EMERGENCY AIRWORTHINESS DIRECTIVE

Number: G-2021-0014-E

Effective Date:	04 November 2021
TCDS:	N/A
Foreign AD (if applicable):	N/A
Superseding AD:	This AD supersedes CAA AD G-2021-0010-E dated 01 October 2021

ATA 28 – Fuel –Cylinder Quick Shut-off Valve Mounting Flange – Inspection / Replacement

Figure 1: *CB437 Flanged Adaptors for Quick Shut-Off (QSO) valves*

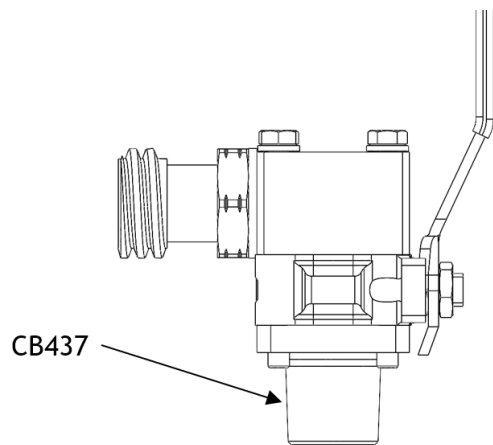
Certain Cameron Hot Air Balloon fuel cylinders are supplied with liquid offtakes that consist of a quarter turn ball valve mounted on a flanged adaptor (P/N CB437, see figure 1). Two recent batches of these adaptors have been manufactured with non-conforming (undersize) threads.

In certain cases, when the minimum sized adaptors are combined with cylinder bosses at maximum tolerance dimension and assembled to fuel cylinders, the thread can impinge (“bottom out”) on the cylinder boss. Although the required tightening torque value can be achieved at installation, the torque required to unscrew the flange could be below the minimum value. In extreme cases the adaptor may be unscrewed by hand.

4. From the 04 October 2021 (the effective date of AD 2021-0010-E), do not install an affected part on any cylinder.
5. Within 4 months after 04 October 2021 (the effective date of AD 2021-0010-E), modify each cylinder by replacing the P/N CB437 issue F QSO flanged Adaptor, with a P/N CB437 issue G (or later issue) QSO flanged adaptor in accordance with the instructions of the SB, or by replacing the QSO valve assembly with a handwheel valve part No CB0824-0001 (this part has a Rego-type hose connection).
